**National Committee on Uniform Traffic Control Devices**

**Bicycle Technical Committee Recommendations  
Approved by the NCUTCD Council January 2008 & June 2008**

**PART 9 - Bicycle Facilities**

Figure 1 shows a sample picture of one of the slides. The sign shown in Figure 1 was also the most effective option.

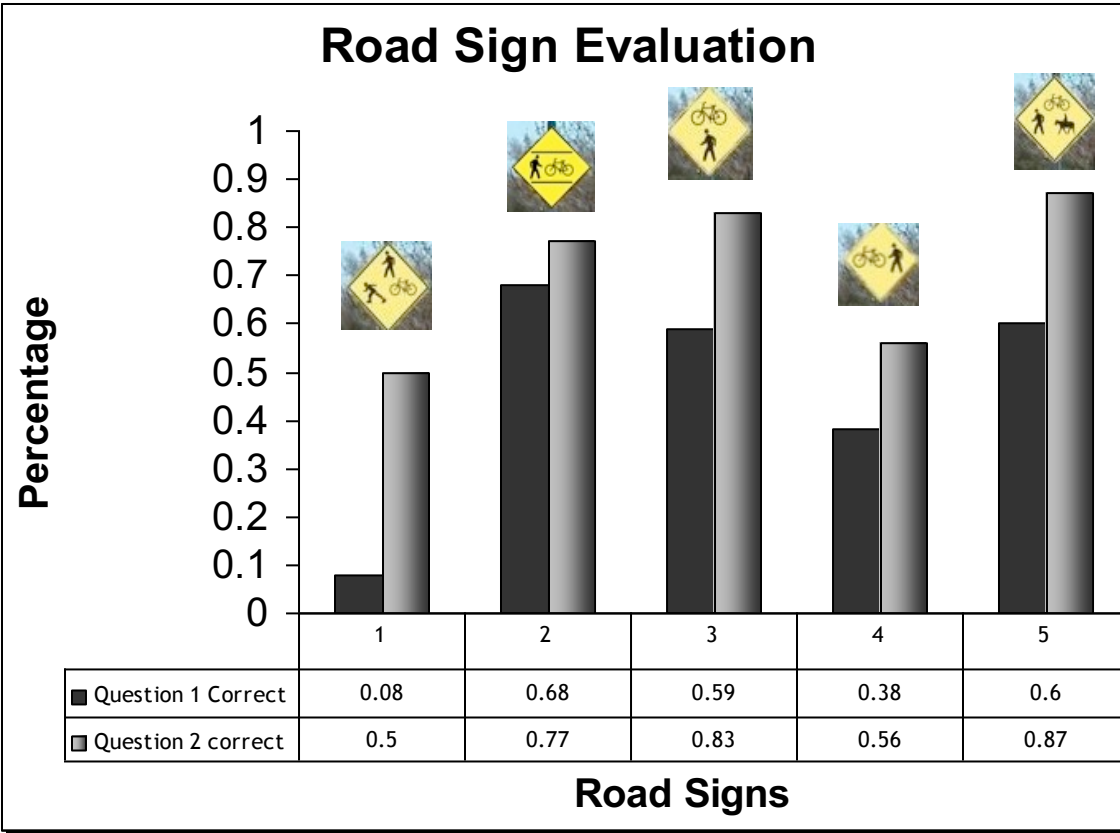
1. In human factors testing commissioned by NCUTCD, the selected W11-15 sign symbol design depicted in the proposed MUTCD tested poorly as compared to other alternative sign designs. Implementing the proposed design as the standard sign for this application will likely result in poor comprehension and legibility. Based on the results of testing (see appendix), NCUTCD recommends the following design for the W11-15 in both Figure 9B-3 and Figure 2C-11:

Overall it appears that sign 3 is most easy to read, and best understood. Sign 5 was also reasonably will understood.
